# Access Compliance Report

## Public Rights-of-Way

Intersection ID: 31891	Main Street: CENTERLINE_DR	Cross Street: MOUNTAIN_SPRINGS_DR	Location: SW
ADA ID: 122D7DBD41FD	Ramp Type: BlendTrans1	Initial Pass/Fail: Fail	Overall Compliance: No
Severity Score: 8.75			
Codes/Mitigation Info/Possible Solution		Field Measurements/Component Compliance

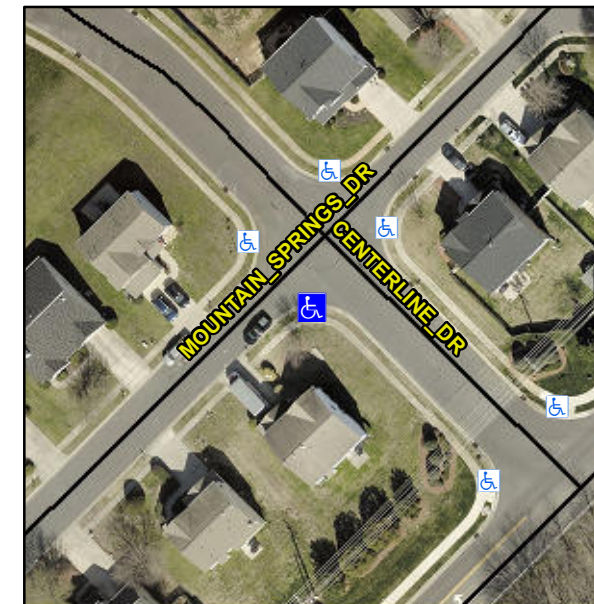
**Not Found, R304.5.1**

**Remove & Replace Curb Ramp With Two New Directional Ramps or Equivalent.**
